**Consumers
Power
Company**

Re: Docket 50-155
DPR-6 ZEK
Proposed Tech Spee
Change 19

Received with dated 12-22-68Consumers Power CompanyDocket No. 50-155Request for Change to the Technical SpecificationsLicense No. DPR-6

Figure 5.2 - Big Rock Point "EEI-UO₂-PuO₂" Fuel

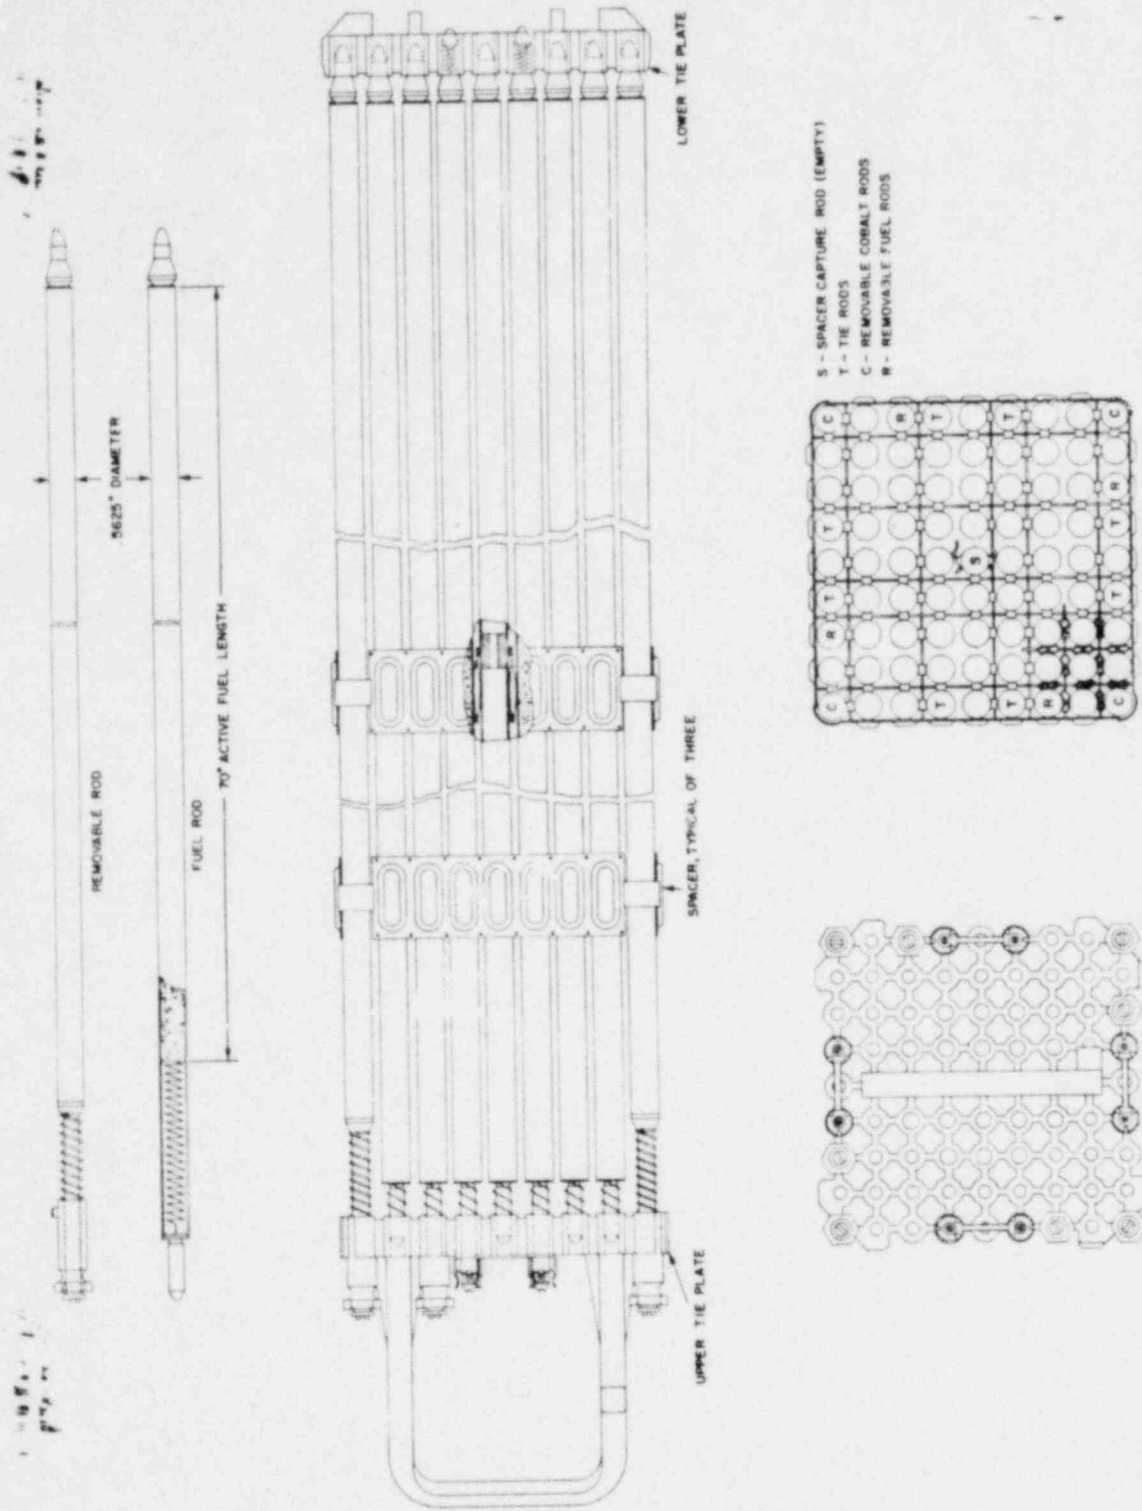
C. In Section 5.1.5 add Figure 5.9.

Figure 5.9 and Figure 1 shows that fuel rod types, positions, and the enrichment distribution within a bundle. Four plutonium enrichments were selected to give adequate power distribution. The fifth plutonium containing fuel rod type contains plutonium of which 80 percent is fissile. The other four plutonium containing rod types contain about 90 percent fissile plutonium. The 80 percent fissile plutonium is deployed in four of the removable rod locations.

Figure 1
BIG ROCK POINT - EEI PHASE II
EPU BUNDLE DESIGN

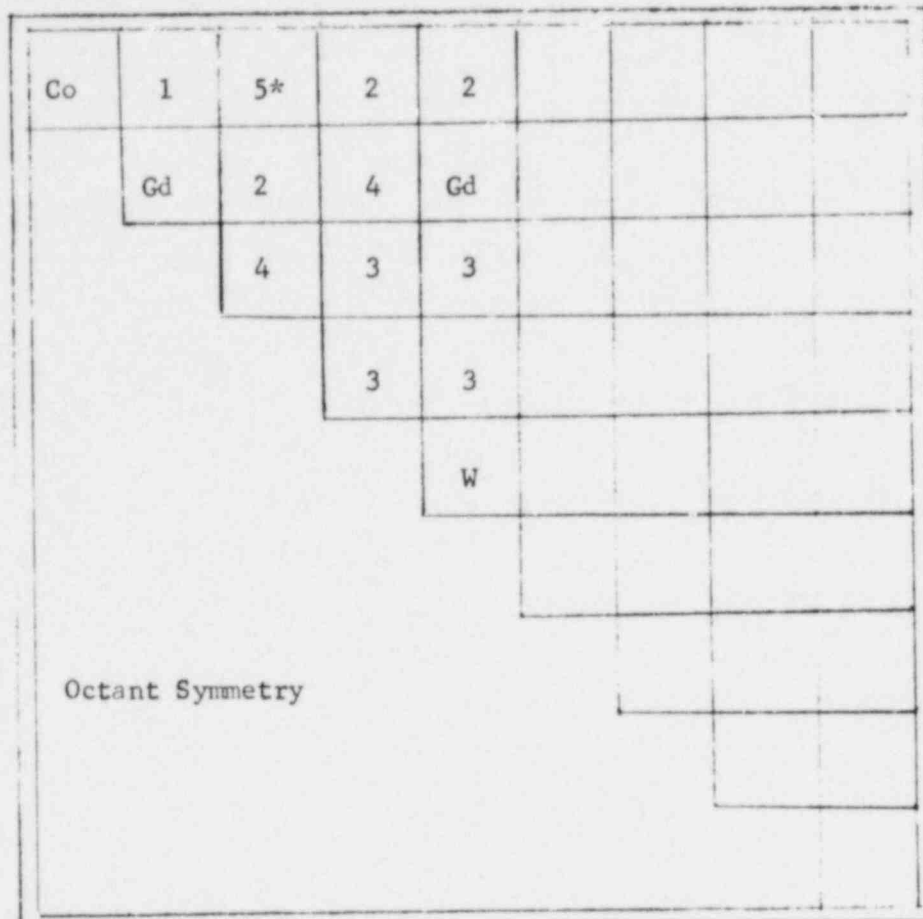
The EEI Bundle, like the "E-G" bundles, are designed to operate for four cycles and achieve an average burnup of 20,000 MWD/T. The design has five different types of plutonia rods. Four types are used to provide an acceptable power distribution and the fifth type provide a test of 80 percent fissile plutonium. Four cobalt rods with 35 gm Co/ft were retained for consistency with the "E-G" design. One spacer-capture tube will be filled with water at the center of the assembly. Eight UO₂-Gd₂O₃ rods augment control in a manner which matches the "E-G" design.

The PuO_2-UO_2 rods all contain cold pressed and sintered fuel pellets of annular design prepared from mechanically blended, ceramic grade UO_2 and PuO_2 powders. The annular hole is 0.150 inch diameter and the fuel matrix density is 92 percent. The only rod-to-rod variation is the plutonium enrichment, which is identified by varying the upper end plug diameter.
